ABBHEY PRIMARY SCHOOL, HEOL PENLAN, NEATH

Stage 3 Road Safety Audit

DC-RDW-20-3061C-RSA3

LOCATION: Pedestrian access to school.

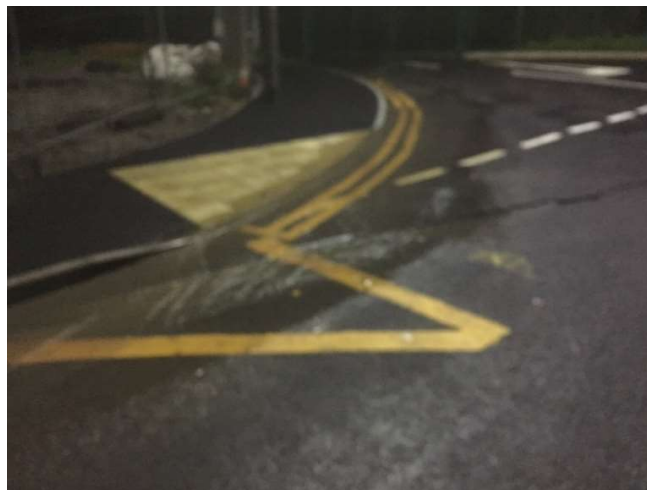
SUMMARY: Trip risk at school pedestrian gate.

There was a difference in level between the footway, the edging kerb and the school footpath that could trip a user.

Amend the levels between the footway and path to remove the trip hazard.
